**RE: Achen Office / Warehouse
6504 Alameda Ave. NE
Grading and Drainage Plan
Engineer's Stamp Date: No Stamp Date
Hydrology File: C18D105**

CONCEPTUAL GRADING PLAN

ACHEN OFFICE/WAREHOUSE
 6504 ALAMEDA AVENUE NE
 SITE DEVELOPMENT PLAN

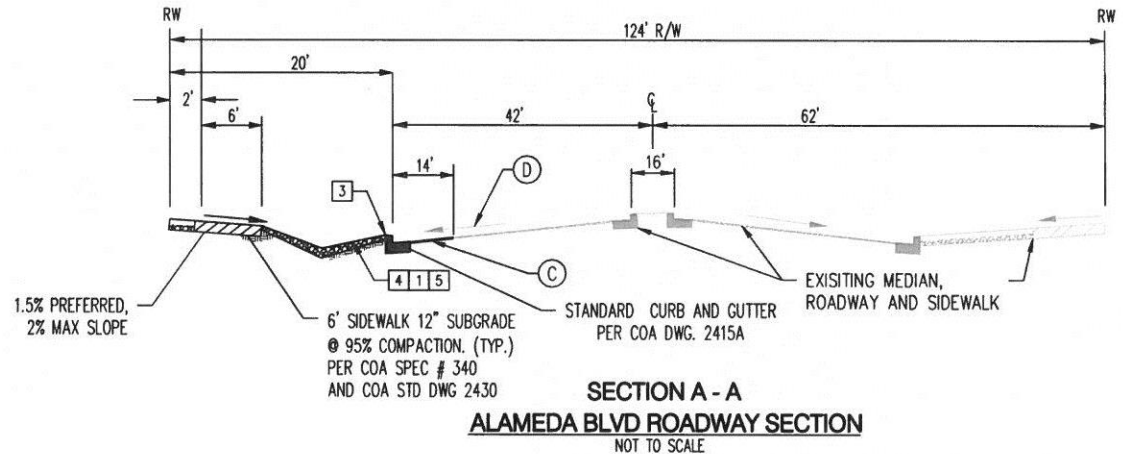
1. Please provide an engineer's stamp with a signature and date.
2. Please add a note stating "Not for Construction".
3. Please label Alameda Ave.
4. Please show the proposed curbing along Alameda Ave and label all work within the R.O.W. to be constructed with work order. Please see the section in the comment #5 for distance of proposed curbing.
5. Please show the adjacent sidewalk and curbing per the section below. Please label this work as being provided per CPN #582385.

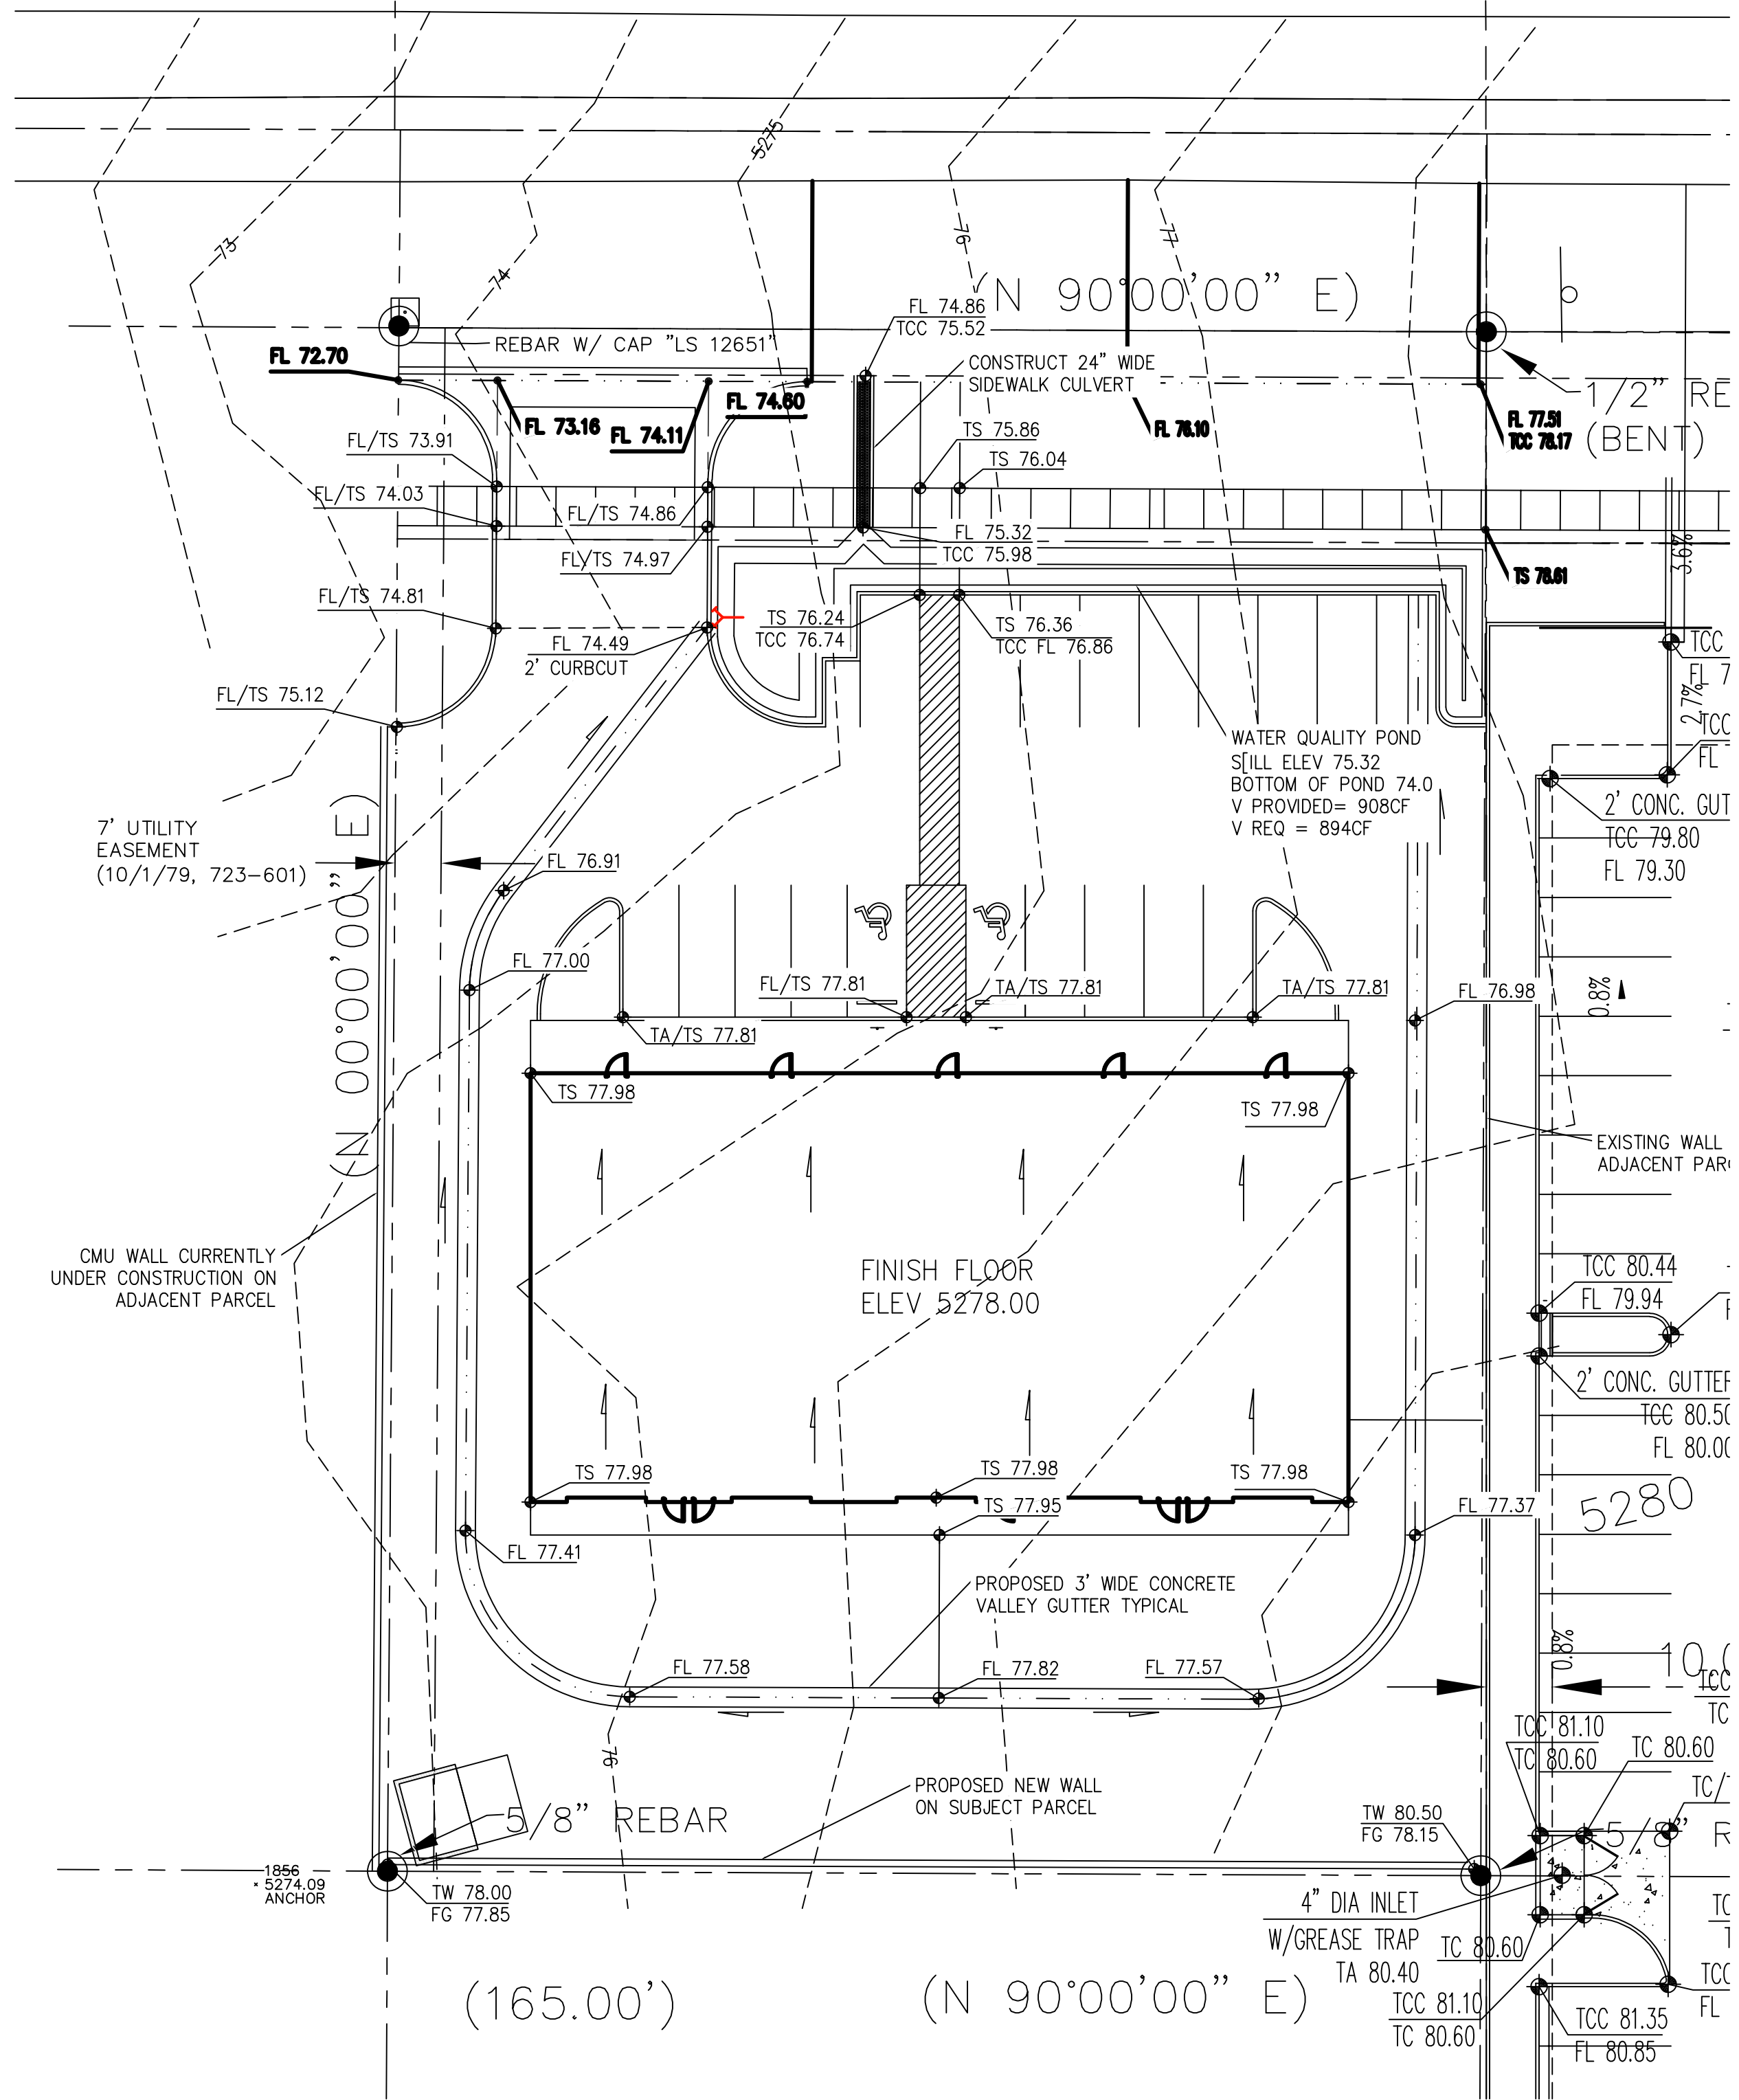
6. Please add a note that this site is within the North Albuquerque Acres Master Drainage Plan and with a design analysis report "Alameda Blvd San Pedro to Wyoming Project #7663.91 by Thompson Engineering dated January 2012, the allowable discharge for this site is 3.82 cfs/ac.

7. The allowable discharge for this site is 2.94 cfs ($3.82 \text{ cfs/ac} \times 0.77 \text{ ac}$). Since the 100 year – 6 hr runoff is 3.29 cfs, the difference will need to be detained onsite. Please either use a routing program like AHYMO or the simplified hydrograph method outlined in the DPM to size the required detention pond. Also provide an outlet structure with calculations. Please note that the required storm water quality volume can be accommodated within the detention pond as well.

9. As we discussed, just ensure that there is no existing drainage from the adjacent property coming into this site. If so, then this can be redirected to the R.O.W. with the workorder plans.

CONCEPTUAL WATER and SEWER PLAN

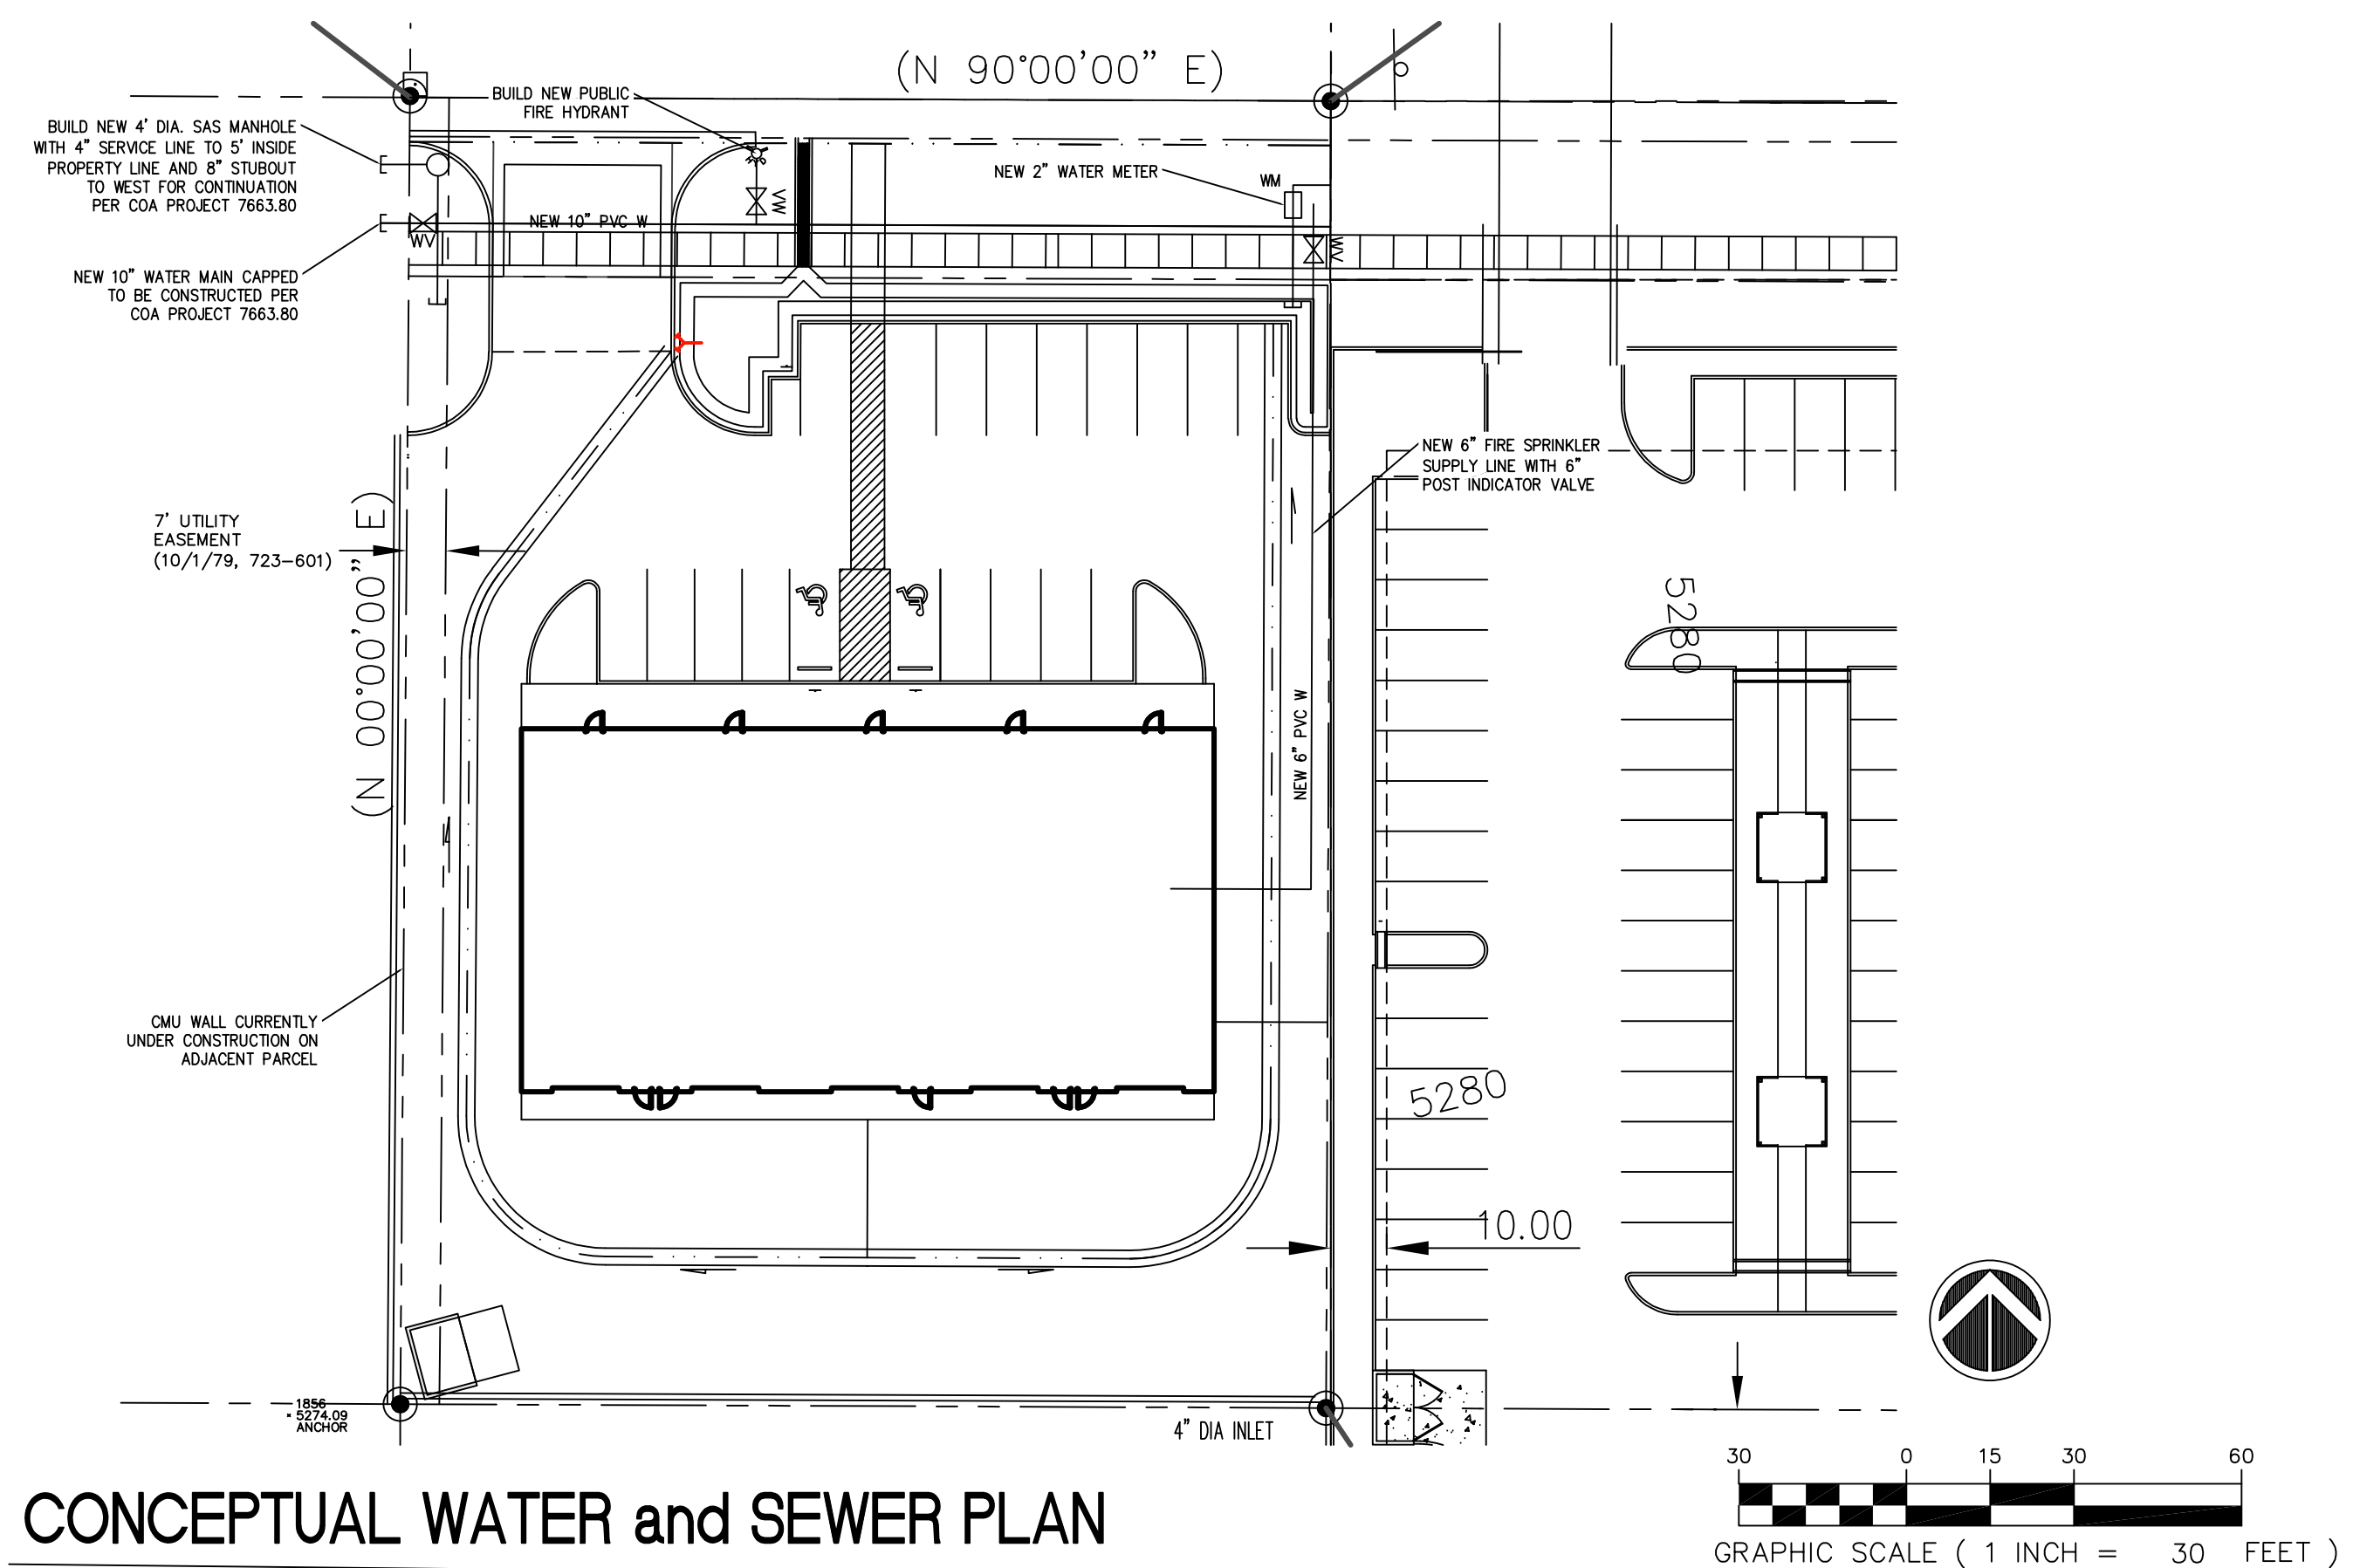
8. The Conceptual Water and Sanitary Sewer Plan doesn't need to be shown on this plan, so this space can be used to show any calculations for the detention pond and the outlet structure.
